VESSEL'S NAME Shells George Brown Rpt. Steel No. 30118

The remarks of the Chief Ship Surveyor are desired on this case for the consideration of the Classing Committee.

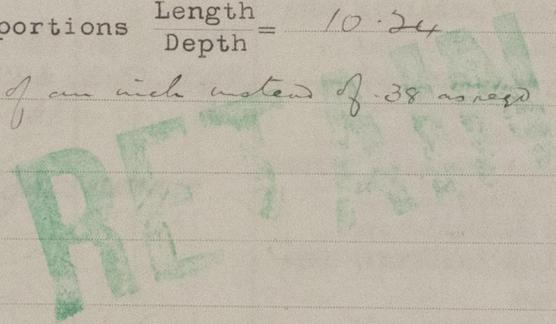
Framing: Table No. 3 page 10

Description Single angle as approved

Deck Sheerstrake .62 of an inch instead of .38 as reqd

This vessel appears to have been built in accordance with the Rules and the approved plans, and it is submitted she is eligible to be classed 100A-1 (Steel) 'Steam Launch' as recommended
